GLASTAR SERVICE BULLETIN 25

MANDATORY

Subject: Variations in wing angle of incidence

Applicability: GlaStar fuselage cage assemblies S/N 001—303 (Serial numbers for cages S/N 001—293 are stamped above the right wing pivot mounting lug; on cages S/N 294 or later, they are stamped on the outboard side of the right taildragger main gear socket. The serial number is also recorded on the Steel Parts Kit Contents List.)

Figure 1

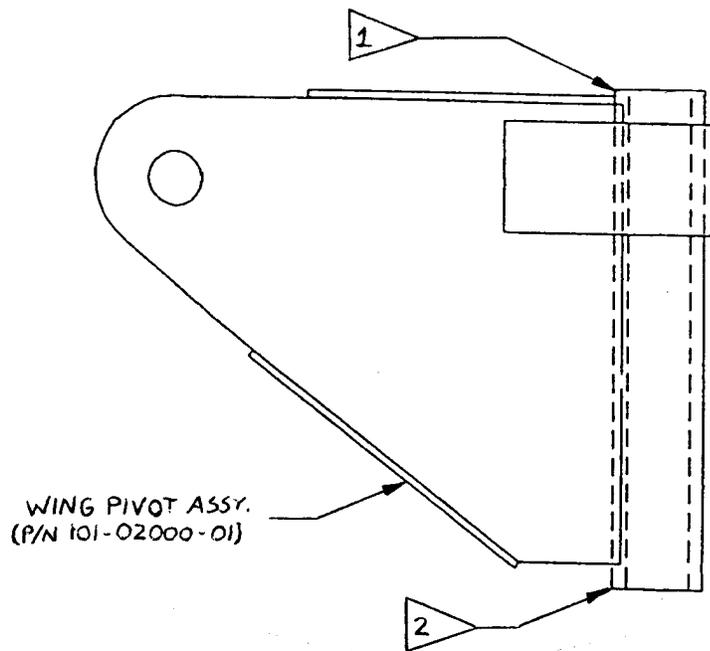
Several builders have taken steps to adjust the incidence angle of the wing on one or both sides by grinding down the wing pivot assemblies (P/N 101-02000-01) at the locations indicated by Flags 1 and 2 in Figure 1 (on the following page) and inserting washers either above or below the pivot, thereby adjusting the trailing edge of the wing up or down to bring the two sides into congruence. This modification has the desired aerodynamic effect, but it can give rise to serious structural concerns. The pivot bolt is designed to handle **shear loads only, not bending loads**. Because washers cannot carry shear loads, insertion of washers between the pivot assembly and the cage lugs has the effect of putting the pivot bolt in bending. For this reason, **a maximum of one standard, .063"-thick AN960 steel washer is permissible between the top of the pivot and the upper cage lug (at Flag 1) or a maximum of two such washers is permissible between the bottom of the pivot and the lower cage lug (at Flag 2).**

- B)** If you measure a difference in incidence angle from left to right of **more than 1.0°**, we **recommend** that you first try to relieve the problem by modifying one or both pivot assemblies and inserting a washer or washers up to the permissible number specified on Page 1. Modify the pivot(s) by grinding away the tube portion of the assembly in the location(s) indicated by Flag 1 and/or Flag 2 in Figure 1. As the figure shows, there is more excess tube material at the bottom (Flag 2) than at the top (Flag 1), so we recommend grinding the bottom first and only grinding the top if necessary to install the maximum number of permissible washers.

Adding a single standard, .063"-thick AN960 washer above or below the pivot will change the angle of the wing by approximately **.15°**, and we expect that this will be sufficient to bring the vast majority of cages within the 1.0° tolerance range.

If you have already modified your pivot assemblies and have installed more than one .063"-thick AN960 washer above or more than two such washers below the pivot, you are **required to replace the pivot assemblies before further flight**. As discussed above, the excess washers have the effect of placing the pivot bolt under unacceptably high bending loads, and therefore **such an installation cannot be considered airworthy**. The required action in this case depends on how far out of tolerance your cage initially was:
